**FINAL ENVIRONMENTAL
IMPACT STATEMENT**

**NEW YORK STATE
DEPARTMENT OF ENVIRONMENTAL CONSERVATION**

**NEW YORK
STATE POLLUTANT DISCHARGE ELIMINATION SYSTEM
(SPDES) PERMITS**

**ROSETON 1 & 2, BOWLINE 1 & 2
AND INDIAN POINT 2 & 3
STEAM ELECTRIC GENERATING STATIONS,
ORANGE, ROCKLAND AND WESTCHESTER COUNTIES**

Fig. 6. Temperature Profile of the Hudson River, NYC to Newburgh, During a Spring Tide¹⁸⁰

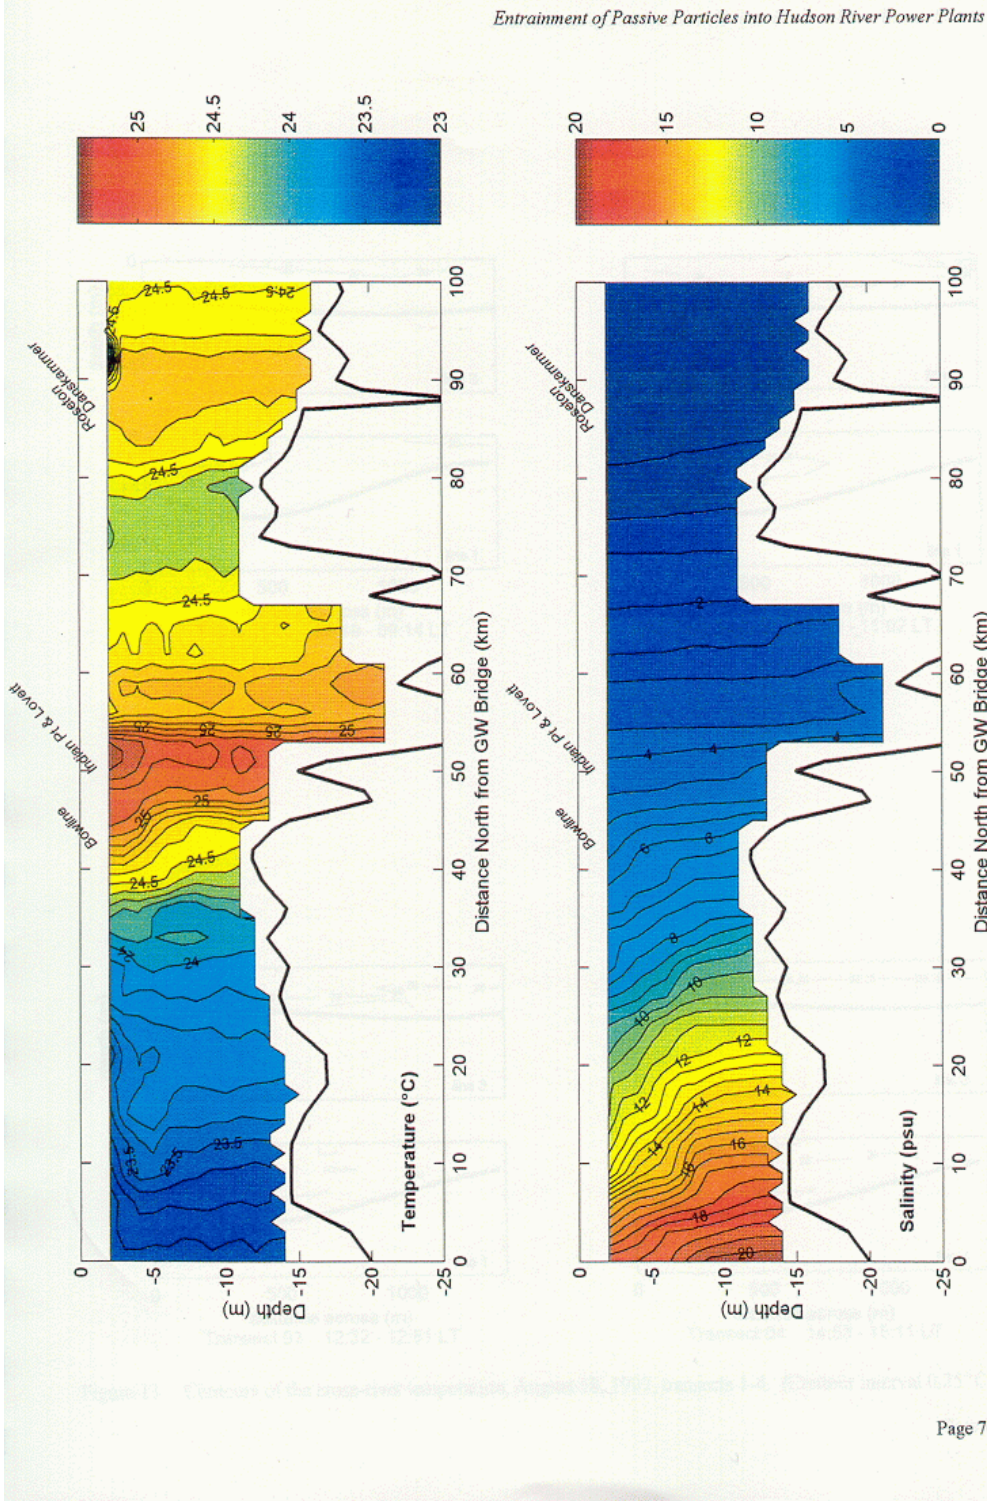
The Department concurs with this comment. Thermal discharges were inadequately addressed in the DEIS. The DEIS asserts, with no supporting evidence, that "... [t]he surface water orientation of the plume allows a zone of passage in the lower portions of the water column, the preferred habitat of the indigenous species." Other data and analyses cast doubt on this assertion.

Some graphics and imagery effectively illustrate the basis for the Department's concerns. A study by HydroQual, Inc., examined passive particle movement and also investigated thermal and salinity profiles in several river reaches, including the portion of the Hudson River where the HRSA plants are located.¹⁷⁸ Figures 6 and 7 of this FEIS (following pages), excerpted from that study, show two vertical temperature profiles of the Hudson River from NYC to just above the northernmost of the HRSA plants, one during a spring and the other during a neap tide. Based on these representations, it appears that there may be times and conditions where effluent-warmed waters occupy nearly the entire vertical water column.

**Fig.8. Thermal Plumes from Indian Point, Unit 3,
and Lovett Station, Tompkins Cove, Hudson River, New York State.**

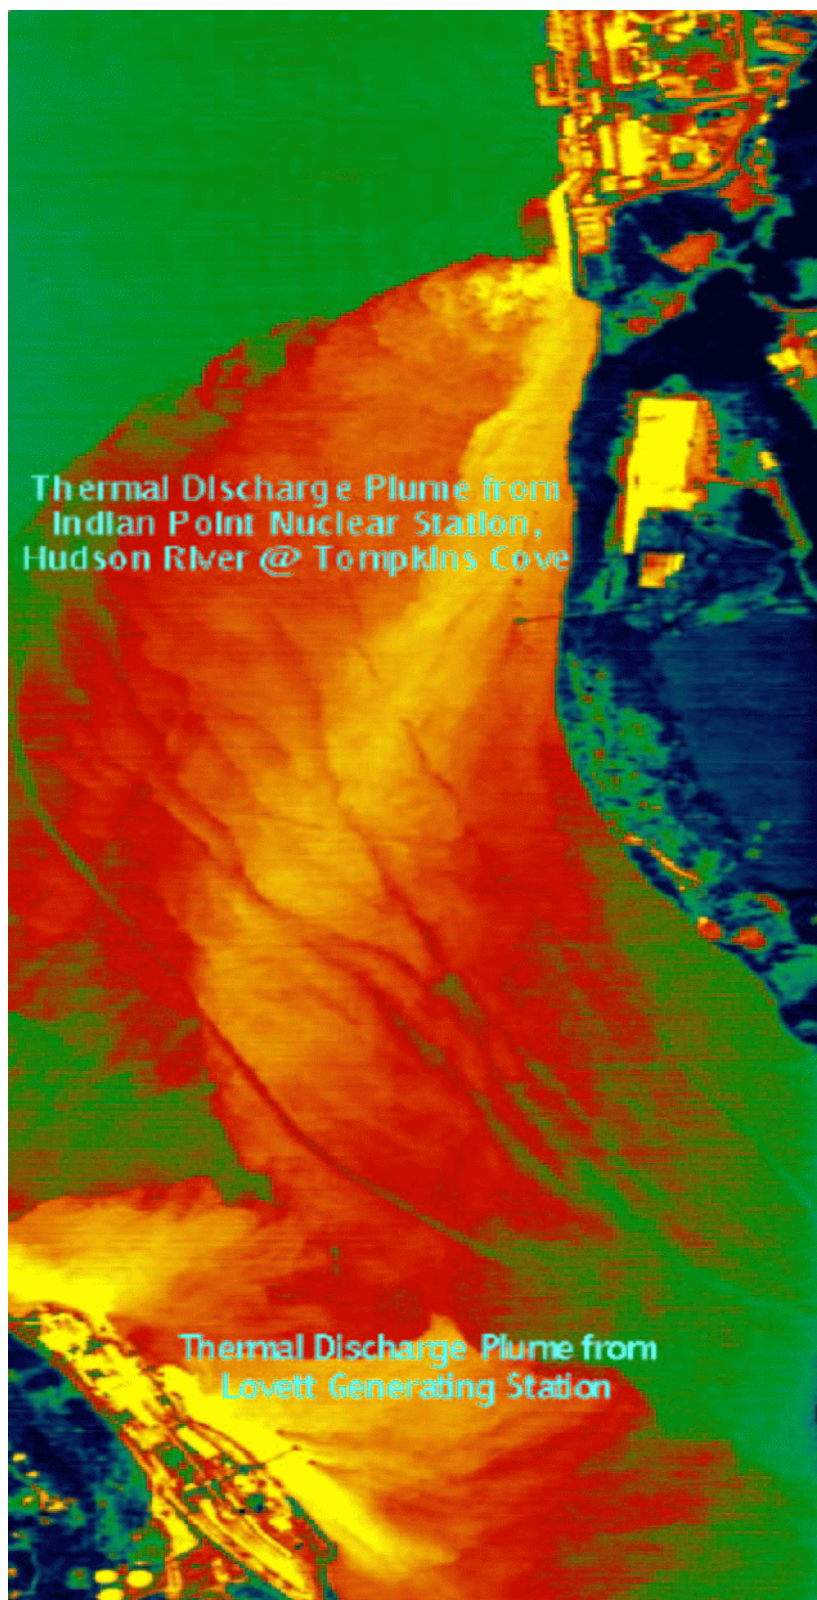
The surface extent of thermal discharges from the HRSA plants is also a concern. Figure 8 is an aerial thermal image of the plume from Indian Point, Unit 3 only, on the east side of the Hudson plus the smaller plume from Lovett on the west bank.¹⁷⁹ In this image, the two plumes came very close to meeting on the surface, even with Indian Point running at less than its full capacity.
